**SERVICE BULLETIN**

**APPLICABILITY:** 2019-23MY Impreza  
 2019-23MY Crosstrek (Including Hybrid Model)  
 2019-23MY Forester  
 2019MY Legacy/ Outback  
 2019-21MY WRX  
 2019-21MY WRX STI  
 2019-21MY BRZ- Navigation -equipped ONLY  
 2019-22MY Ascent

**NUMBER:** 15-236-18R

**SUBJECT:** Reprogramming File Availability for Optimization of Harman Gen 3.1 and Gen 3.1α Audio and Navigation Head Units

**NOTE 3:** When using a USB connection with iPhone (CarPlay active), move to CarPlay screen.

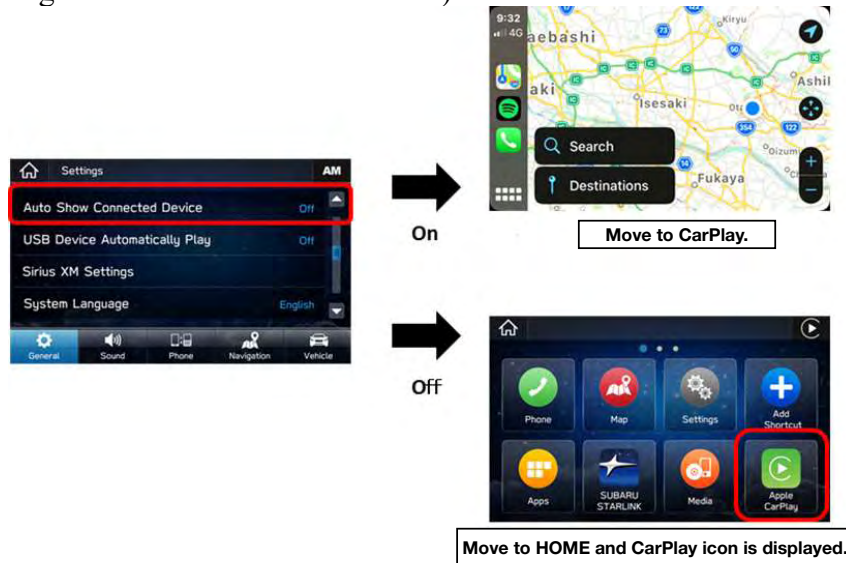
Setting in <Auto Show Connected Device>

ON: The CarPlay screen is displayed.

OFF: The CarPlay icon is displayed but the CarPlay screen is not displayed.

The <Auto Show Connected Device> is no longer available for CarPlay. The Setting menu shows only <Android Auto> to access the <Auto Show Connected Device> selection menu. If an iPhone with active CarPlay is connected, the Head Unit always moves to the CarPlay screen.

**NOTE 4:** Displaying Repair Facility POI icons:

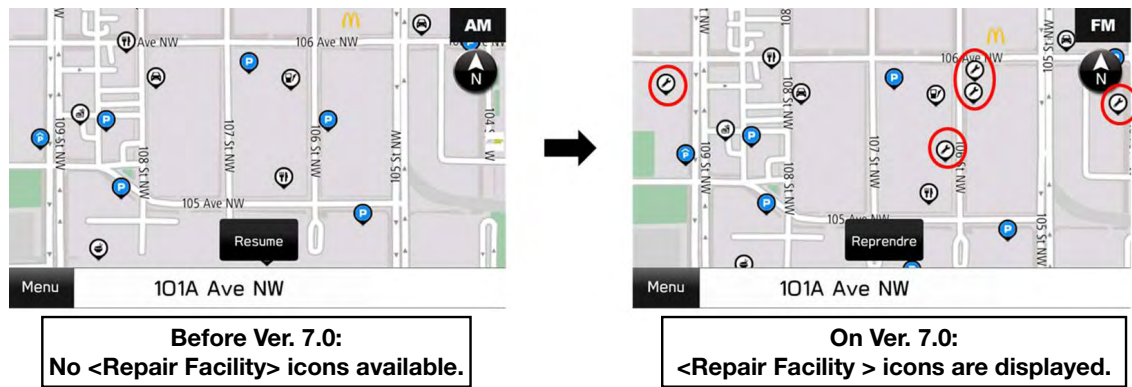
<Repair Facility> Icons can be displayed in the NAVI Map.

<Repair Facility> Icons can be turned On or OFF by going to: Settings > Navigation > POI Icons.

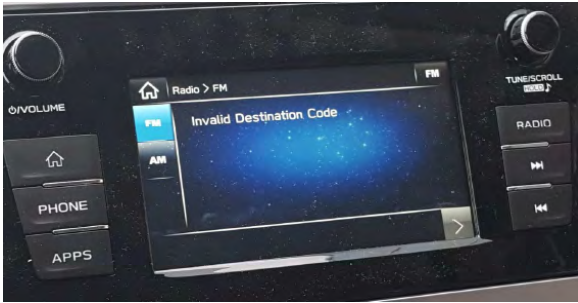
<Scan> previously displayed on SXM screen was changed to <Tune Scan> (a.k.a. SEEK).
